RYANS ROAD INDUSTRIAL DEVELOPMENT – **DRAFT** CANTERBURY REGIONAL COUNCIL CONSENT CONDITIONS 26/03/26

Column 1: Applicant's Proposed Conditions – Section 55 Response	Column 2: Summary of Section 53 Comments and Response to Changes Requested
<p><i>Note: Green cells indicate the condition wording is agreed between CGL and CRC with no changes from CRC's Appendix 5 conditions.</i></p> <p><i>Note: Orange cells indicate the condition wording has been changed by CGL from CRC's Appendix 5 set and explains why the change have been made in response to s53comments. The proposed changes have subsequently been agreed with CRC on 19 November 2025.</i></p>

ALL CONDITIONS ARE ACCEPTED BY THE PANEL. HOWEVER PLEASE NOTE PANEL COMMENTS BENEATH THE TABLES BELOW.

Canterbury Regional Council: S15 Discharge Permit Plans – Construction Phase (APPLICANTS COMMENT: note: these plans were provided by CRC for inclusion and may require further update to reflect the current plans as the application progresses through the process).

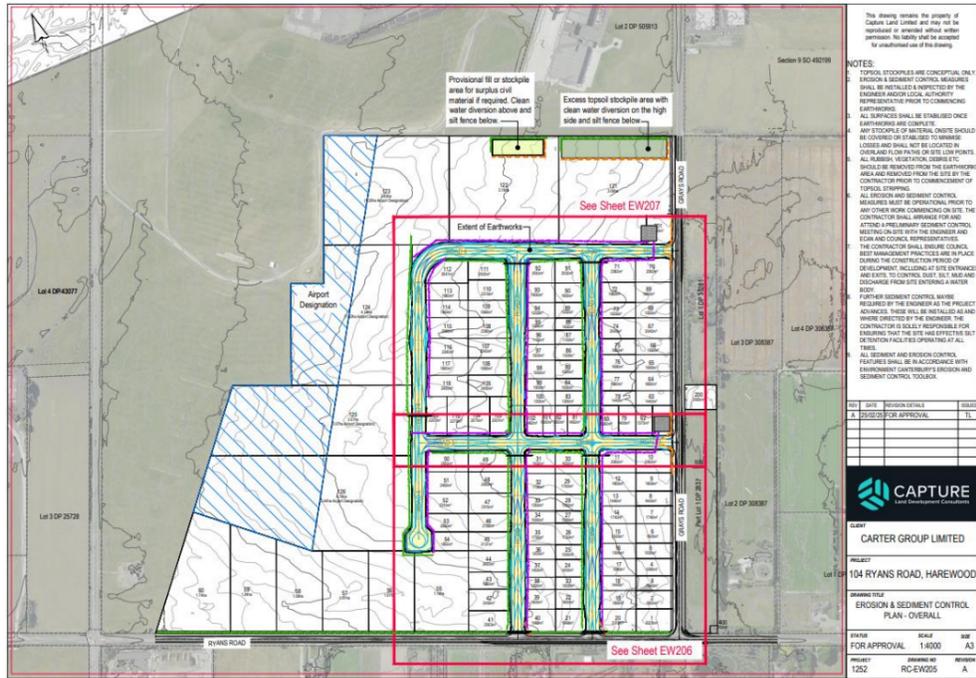
PANEL COMMENT: The Applicant is requested to confirm the relevant versions of these plans.

Canterbury Regional Council: S15 Discharge Plans– Operational Phase: Roads, Berms and Footpaths (APPLICANTS COMMENT: note: these plans were provided by CRC for inclusion and may require further update to reflect the current plans as the application progresses through the process).

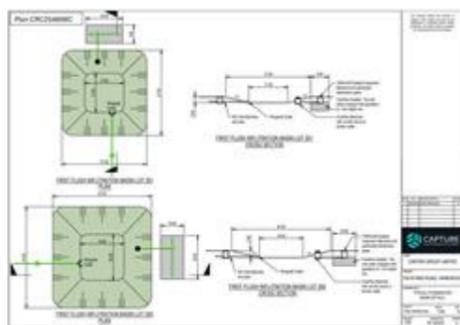
PANEL COMMENT: The Applicant is requested to confirm the relevant versions of these plans.
